**Invitation to Bid (ITB)
ITB # 20-VSW-EMM-012**

Addendum Two

**Construction of All Season River Intake,
Emmonak, Alaska**

Sheet No. C304

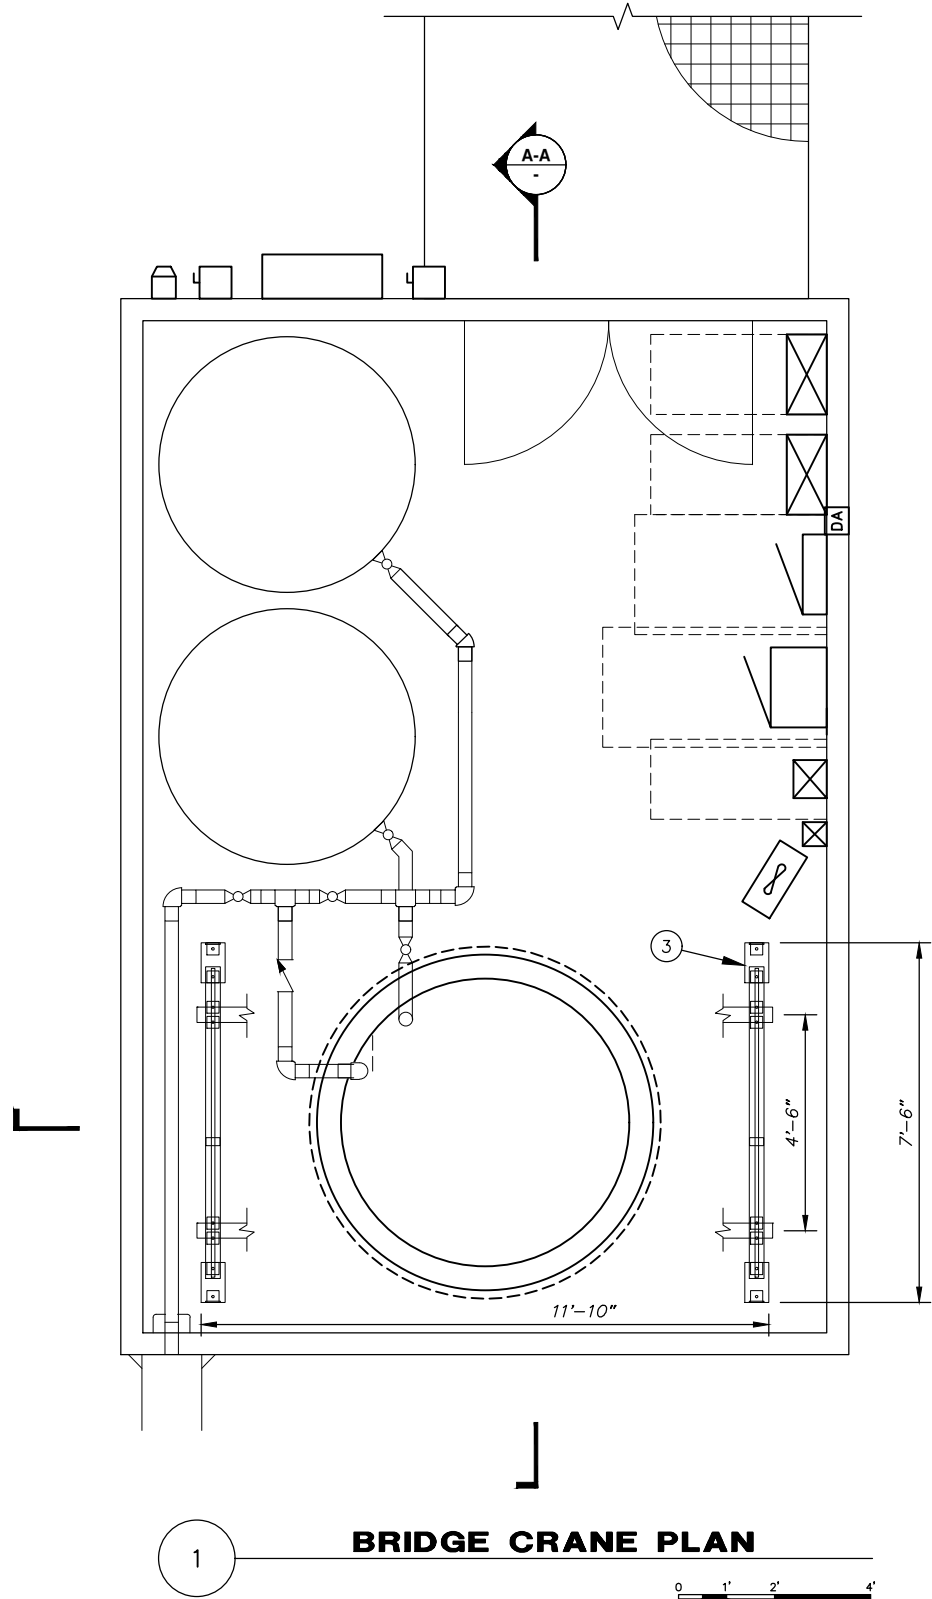
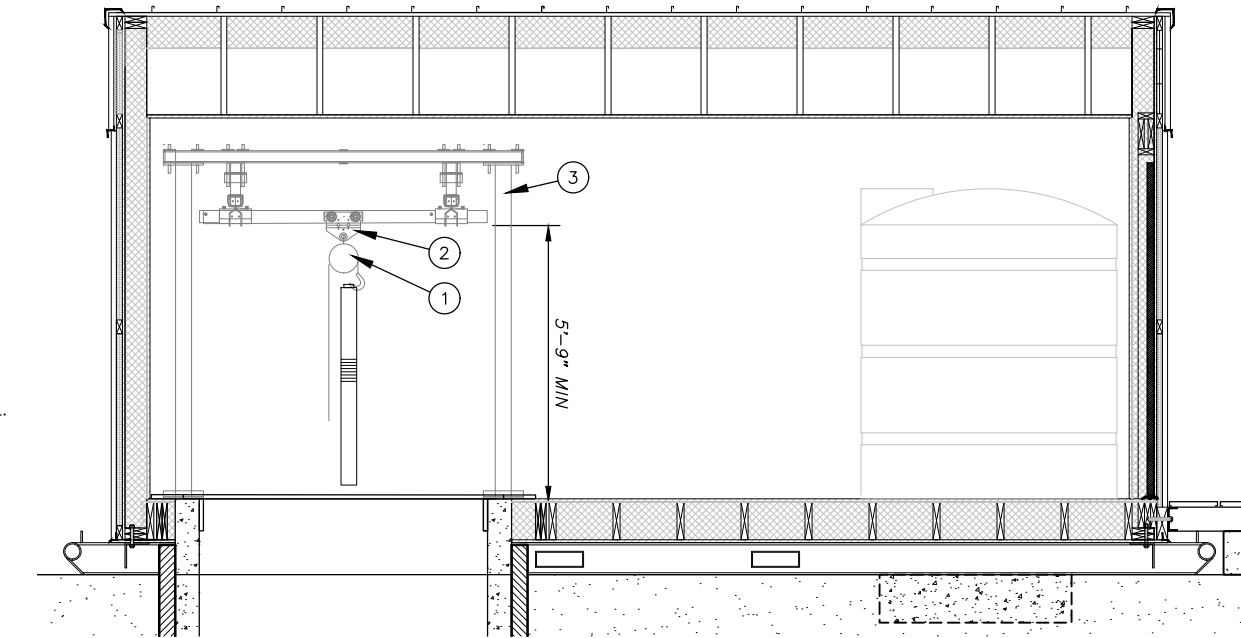
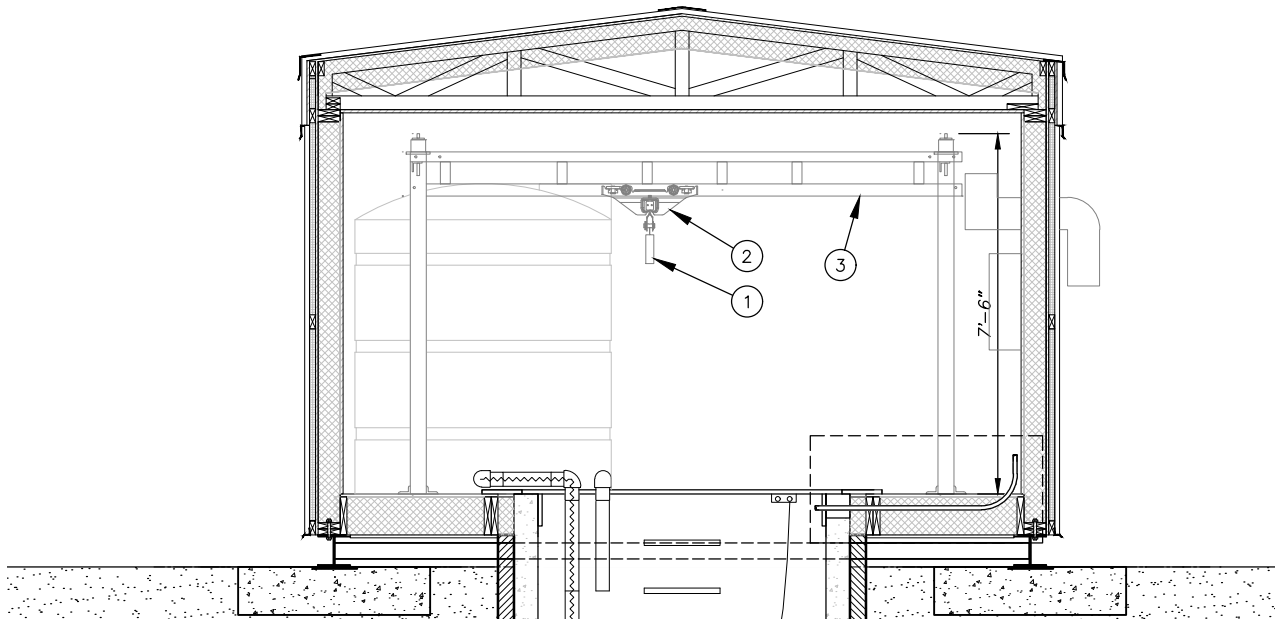
Requirement for chain length and chain bag added.

1 **MECHANICAL PLAN - HVAC**
SCALE: 1/2" = 1'-0"

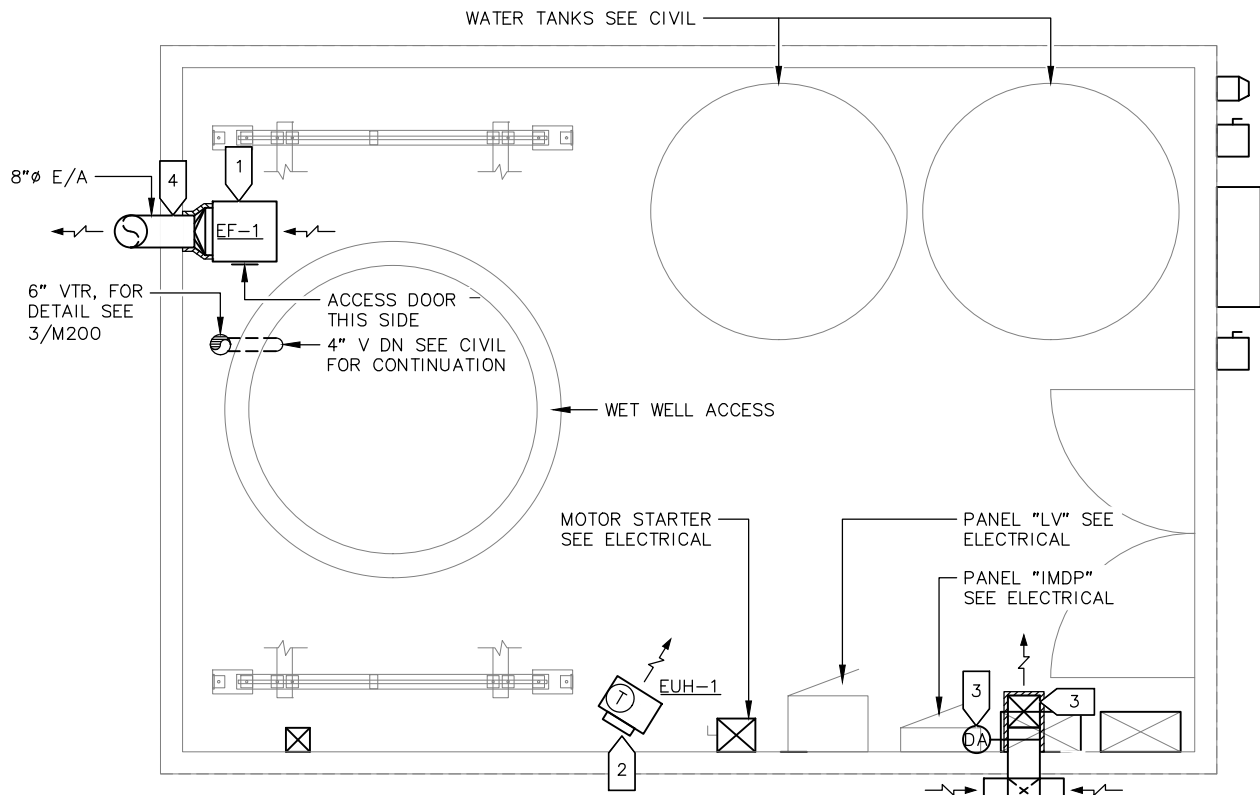
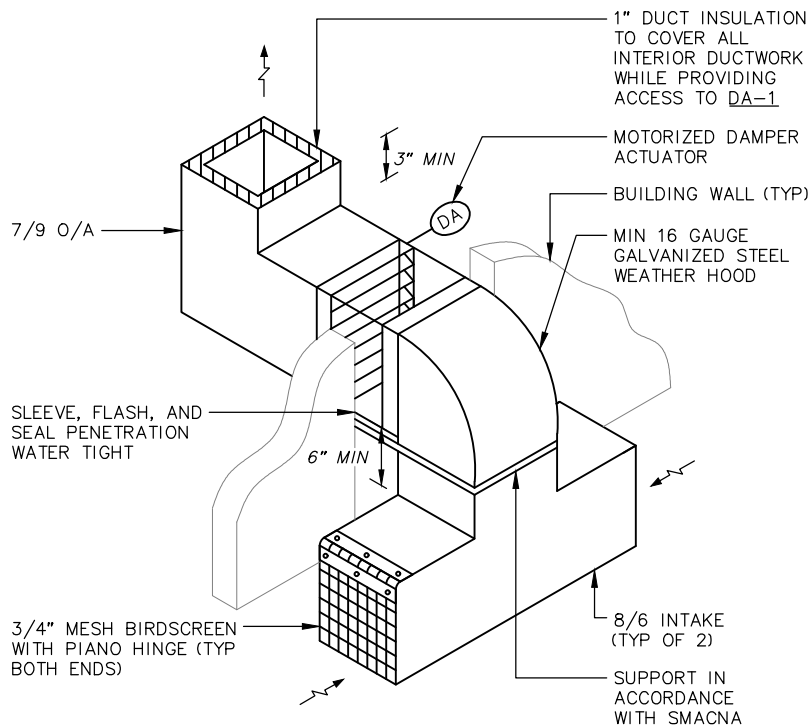
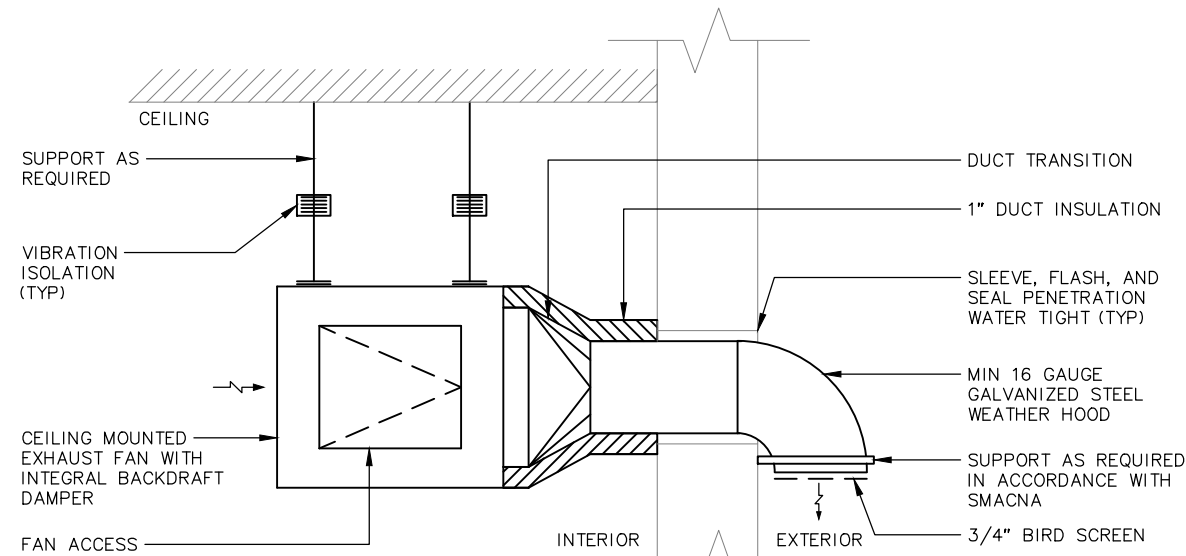
Revised intake hood and mounting height

E200

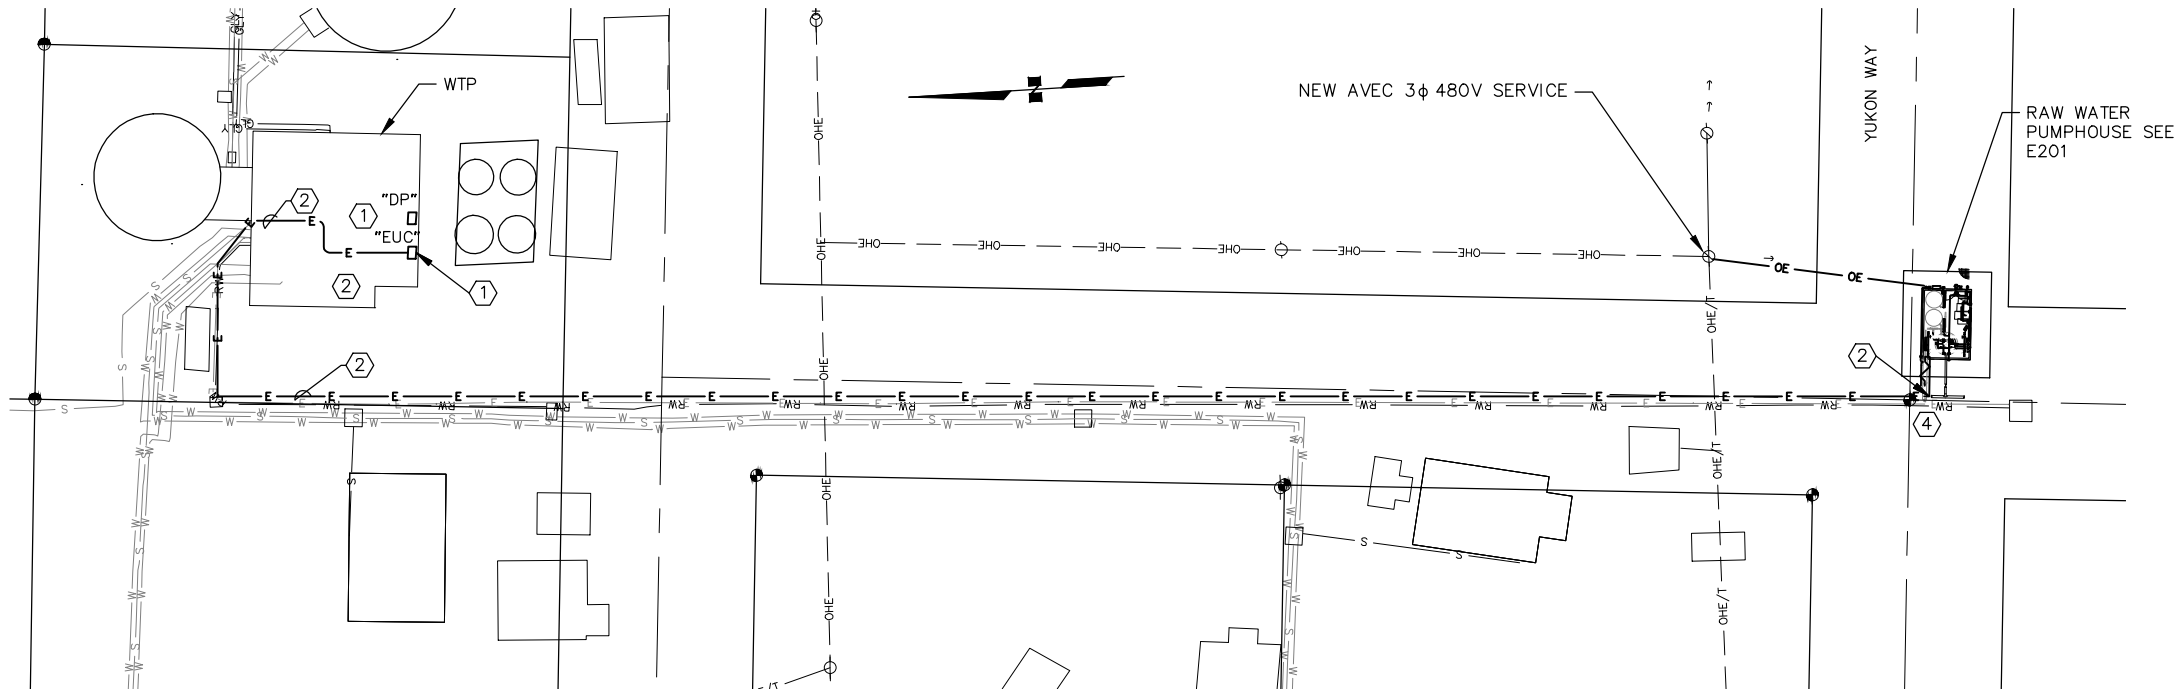
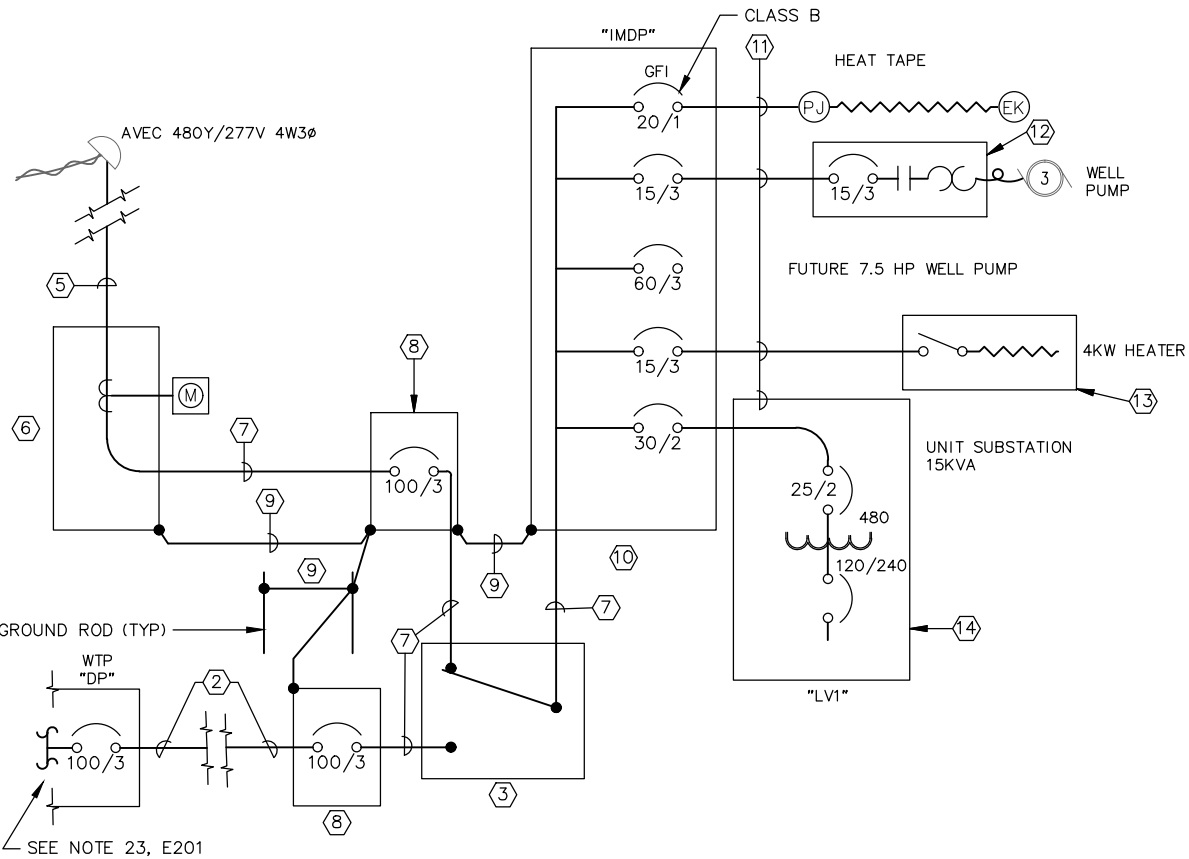
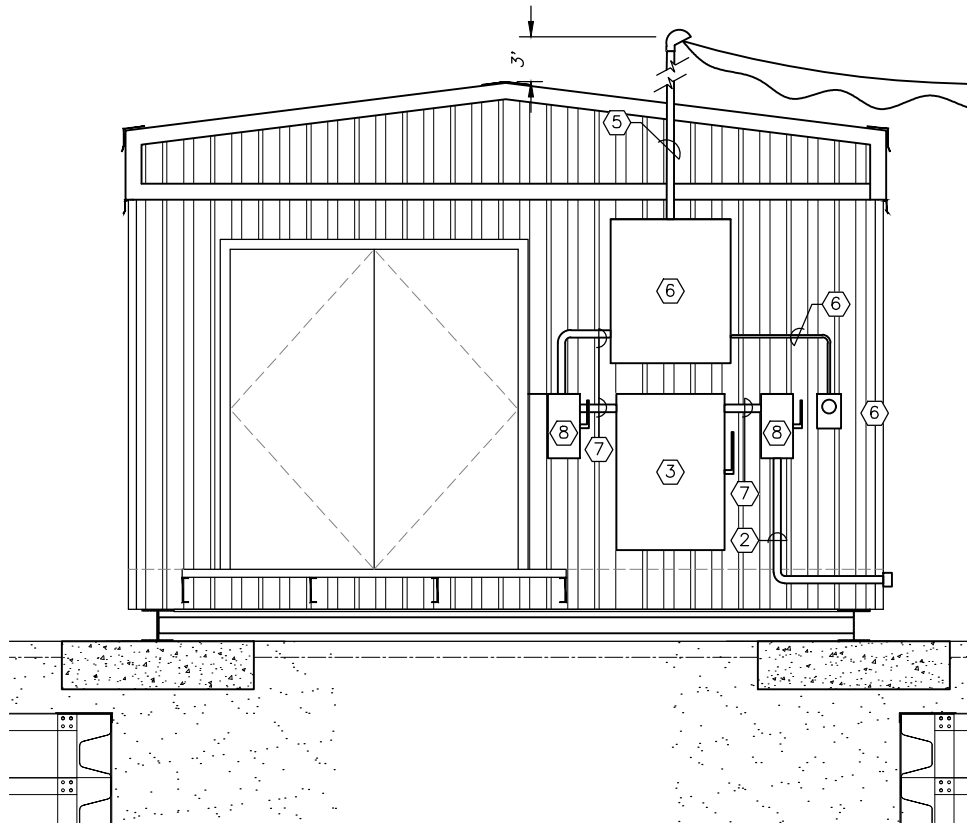
Detail 2 – Minor clarifications and changed breaker size for future pump
Detail 3 – Corrected scale of conduits and added dimension for weather head
Notes – Minor revisions to notes 1, 2, 5, 8, 9, 13 and 14
